Illustrated Parts List - IPL Update

H572XP/XPG

1. Air filter

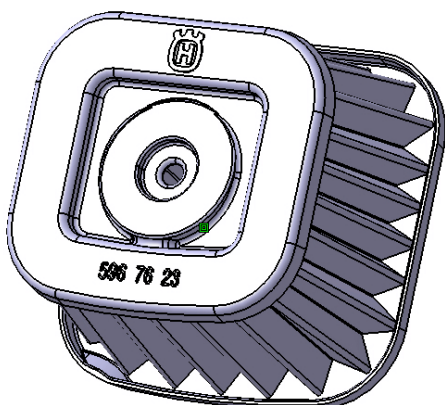
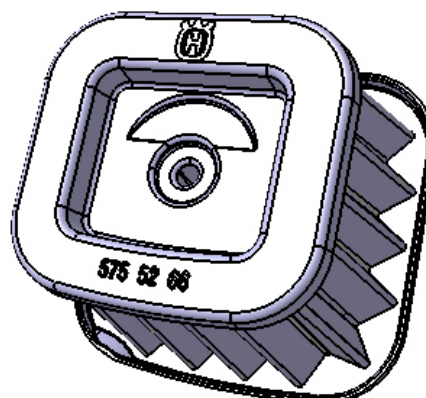
1. We have implemented new Air filter assy to avoid collision between air filter and cylinder cover.
 New colour of Air filters:
- | | | |

H = 46 mm

H = 51 mm

New version

596 76 23-01/-02/-03

Old version

575 52 66-01/-02/-03
